Transmission scheme for GEPOF (data payload scaling corrigendum)

Rubén Pérez-Aranda
(rubenpda@kdpof.com)

Transmission scheme - data payload THP & scaling

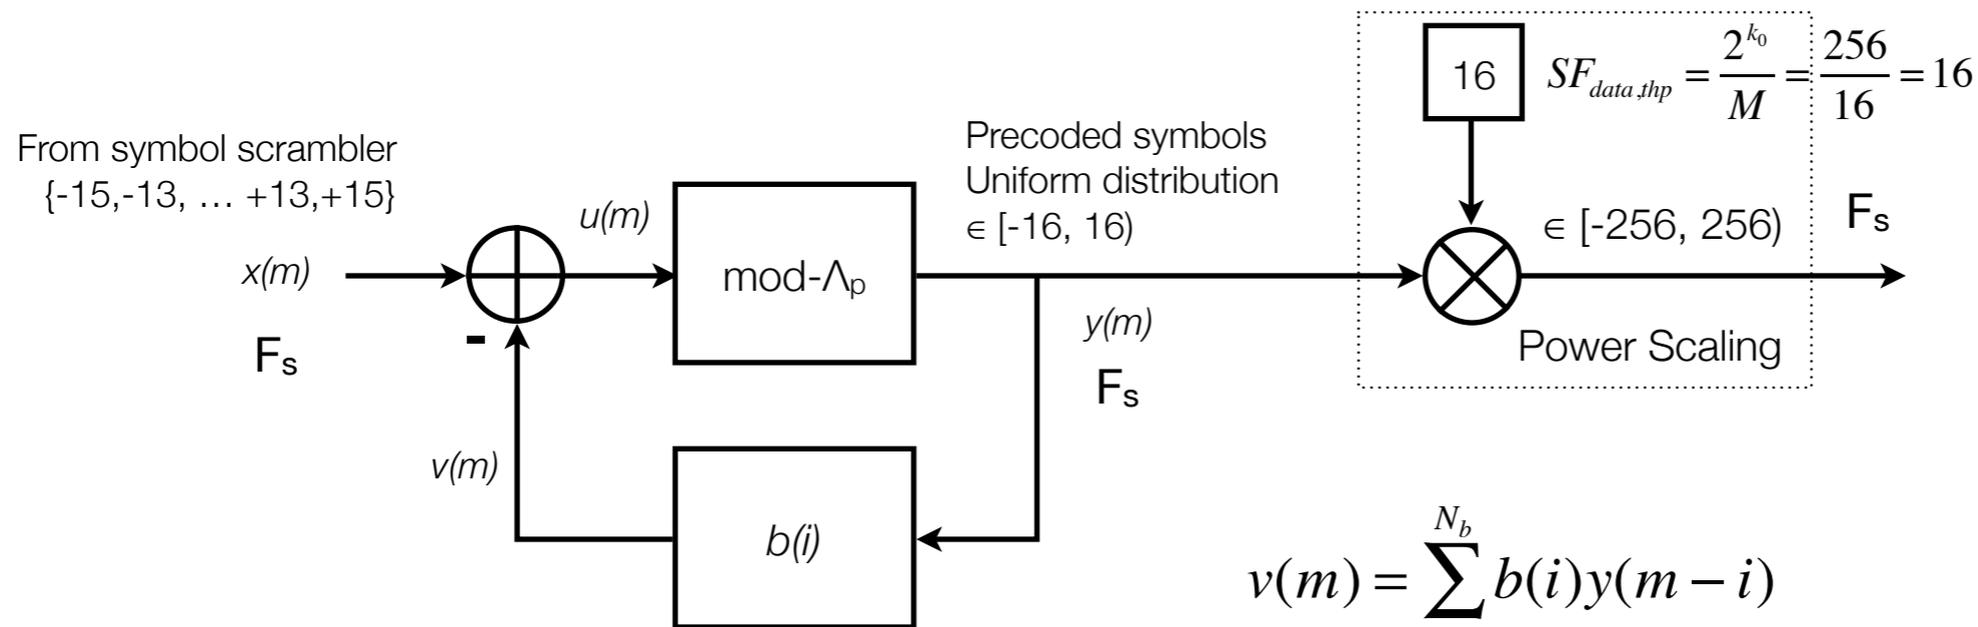
- A typo error was found in the definition of the amplitude scaling used to transmit the payload data section in the transmission scheme, so the OMA is preserved almost equal for every section (pilots, header subframes and payload code-words)
- Although the scaling factor is correct, not the range indicated in the output
- This presentation fix the error

$$y(m) = \text{mod}((u(m) + M), 2M) - M = \text{mod}((u(m) + 16), 32) - 16$$
